Access Compliance Report

Intersection ID: 23162	Main Street: SHARON_RD_WEST	Cross Street: SOUTH_BV	Location: NE
ADA ID: DB45F598C9F7	Ramp Type: Perp	Initial Pass/Fail: Fail	Overall Compliance: No
Severity Score: 13.75			
Codes/Mitigation Info/Possible Solution		Field Measurements/Component Compliance

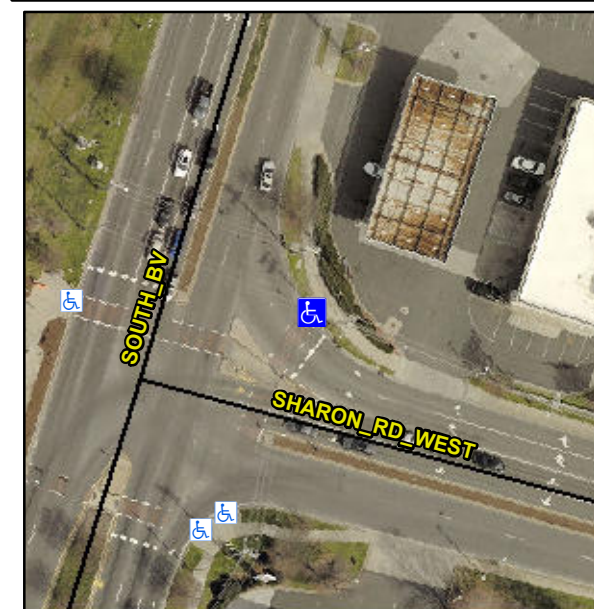
Not Found, R304.2.2, R304.5.3

Compliance	Description	Data	Compliance	Description	Data
N/A	Ramp Length (in)	72.0	No	Ramp Slope (%)	9.7
Yes	Ramp Width (in)	54.0	No	Ramp XSlope (%)	3.9
N/A	Flare Type LT	N/A	N/A	Flare Type RT	N/A
N/A	Flare Slope LT (%)	N/A	N/A	Flare Slope RT (%)	N/A
N/A	Flare Traversable LT?	N/A	N/A	Flare Traversable RT?	N/A
N/A	Landing Length (in)	N/A	N/A	DWS Provided?	N/A
N/A	Landing Width (in)	N/A	N/A	DWS Contrast?	N/A
N/A	Landing Slope (%)	N/A	N/A	DWS Length (in)	N/A
N/A	Landing X Slope (%)	N/A	N/A	DWS Full Width?	N/A
N/A	Landing Curb? (Y/N)	N/A	N/A	DWS Offset (in)	N/A
N/A	Shared Landing?	N/A			
N/A	Gutter Ponding?	N/A	N/A	Gutter Slope (%)	N/A
N/A	Gutter Lip Ht (in)	N/A	N/A	Gutter X Slope (%)	N/A
N/A	Painted X Walk1?	Yes	N/A	Painted X Walk2?	N/A
	X Walk 1 Direction	To SW		X Walk 2 Direction	N/A
N/A	X Walk 1 Width (in)	123.0	N/A	X Walk 2 Width (in)	N/A
	X Walk 1 Slope (%)	2.3		X Walk 2 Slope (%)	N/A
	X Walk 1 X Slope (%)	3.5		X Walk 2 X Slope (%)	N/A

Remove & Replace Entire Ramp.
